Access Compliance Report

Public Rights-of-Way

(Curb Ramps)

Intersection ID: 6653	Main Street: TYNER_ST	Cross Street: UNIVERSITY_CITY_BV	Location: SE
ADA ID: 3BB0532A4EA5	Ramp Type: BlendTrans1	Initial Pass/Fail: Fail	Overall Compliance: No
Severity Score: 8.75			
Codes/Mitigation Info/Possible Solution		Field Measurements/Component Compliance

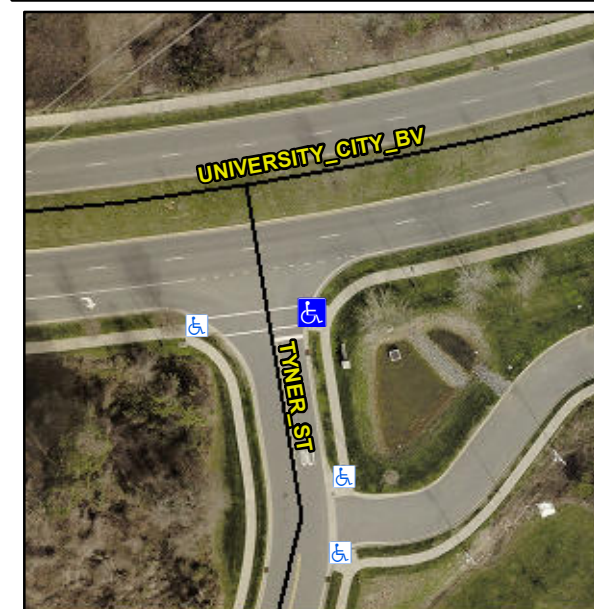
Not Found, R304.5.1

Compliance	Description	Data	Compliance	Description	Data
N/A	Ramp Length (in)	75.0	Yes	BlendTrans Slope (%)	2.1
No	Ramp Width (in)	45.0	Yes	BlendTrans XSlope (%)	0.9
N/A	Flare Type LT	N/A	N/A	Flare Type RT	N/A
N/A	Flare Slope LT (%)	N/A	N/A	Flare Slope RT (%)	N/A
N/A	Flare Traversable LT?	N/A	N/A	Flare Traversable RT?	N/A
N/A	Landing Length (in)	N/A	N/A	DWS Provided?	N/A
N/A	Landing Width (in)	N/A	N/A	DWS Contrast?	N/A
N/A	Landing Slope (%)	N/A	N/A	DWS Length (in)	N/A
N/A	Landing X Slope (%)	N/A	N/A	DWS Full Width?	N/A
N/A	Landing Curb? (Y/N)	N/A	N/A	DWS Offset (in)	N/A
N/A	Shared Landing?	N/A			
N/A	Gutter Ponding?	N/A	N/A	Gutter Slope (%)	N/A
N/A	Gutter Lip Ht (in)	N/A	N/A	Gutter X Slope (%)	N/A
N/A	Painted X Walk1?	No	N/A	Painted X Walk2?	Yes
	X Walk 1 Direction	To N		X Walk 2 Direction	To W
	X Walk 1 Width (in)	N/A		X Walk 2 Width (in)	112.0
	X Walk 1 Slope (%)	3.8		X Walk 2 Slope (%)	0.3
	X Walk 1 X Slope (%)	0.9		X Walk 2 X Slope (%)	0.3

N/A	Ramp inside XWalk1?	N/A	N/A	Ramp inside XWalk2?	Yes
	Road Slope (%)	1.1		Clear Space?	N/A
	Road X Slope (%)	0.9	N/A	Clear Space to XWalk (in)	N/A
N/A	Any Obstructions?	N/A	N/A	Storm Grate/Utility Hazard?	N/A
	Obstruction Type			Storm Grate/Utility Type	
		N/A			N/A
			Yes	Surface Condition? (G/P)	Good
			No	Curb Slope (%)	7.7

Remove & Replace Curb Ramp With Two New Directional Ramps or Equivalent.
